**RE: NMAC Building (Gym/Volleyball Courts)
Grading and Drainage Plan
Engineer's Stamp Date 1-20-2016 (File:D16D002F)**

Based upon the information provided in your submittal received 2-5-2016, the above referenced Grading and Drainage Plan is approved for Building Permit, with the following condition:

GRADING & DRAINAGE PLAN

N M A C B U I L D I N G
ALBUQUERQUE • NEW MEXICO
GRADING & DRAINAGE PLAN

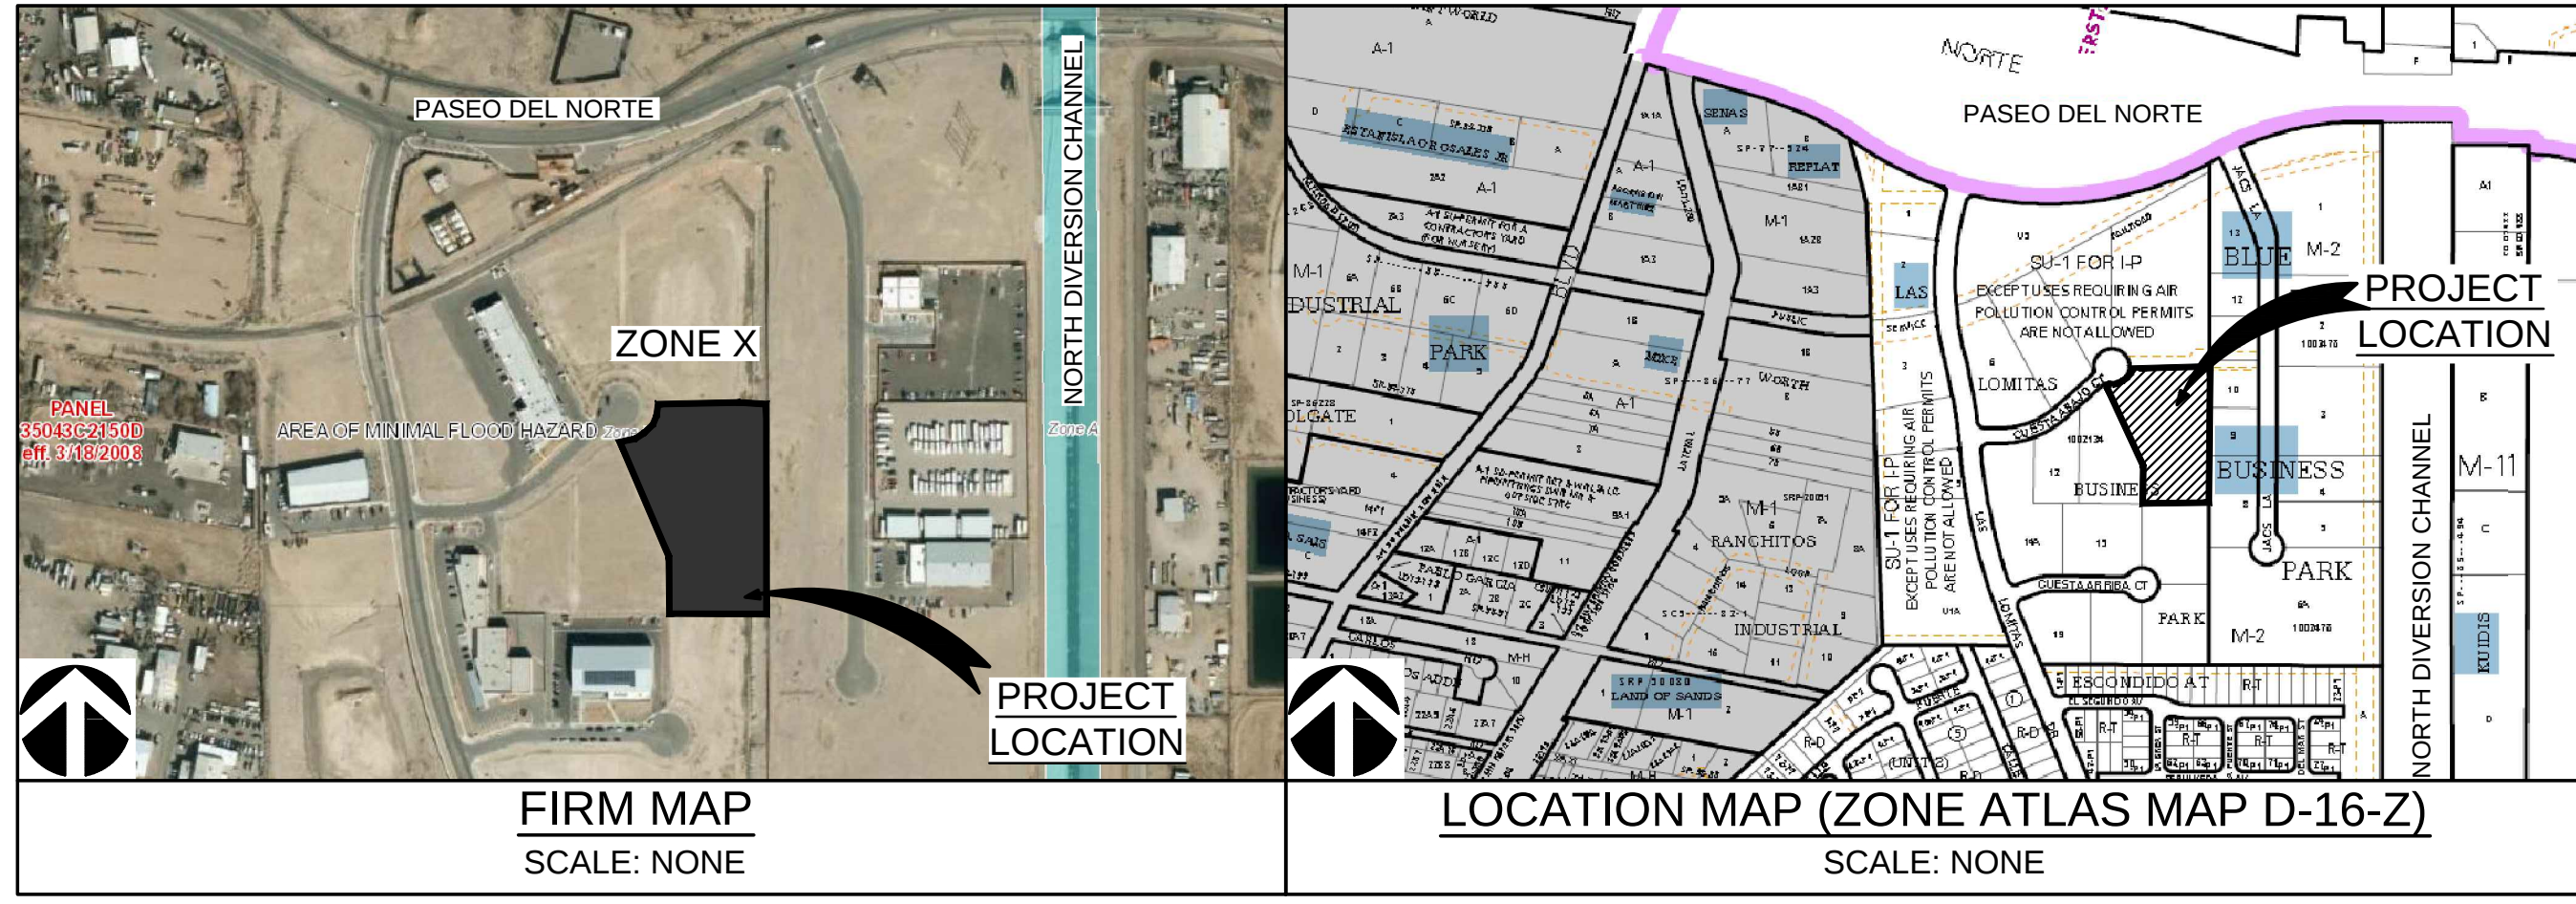
1. Increase the volume of the larger first flush pond to offset the lack of flow expected to get to the three parking lot planters (the parking lot planter depressions can be eliminated). Please show the change on the as-built set when submitting the Certification.
2. Submit an ESC Plan and an ESC Grading Permit prior to any earthwork.
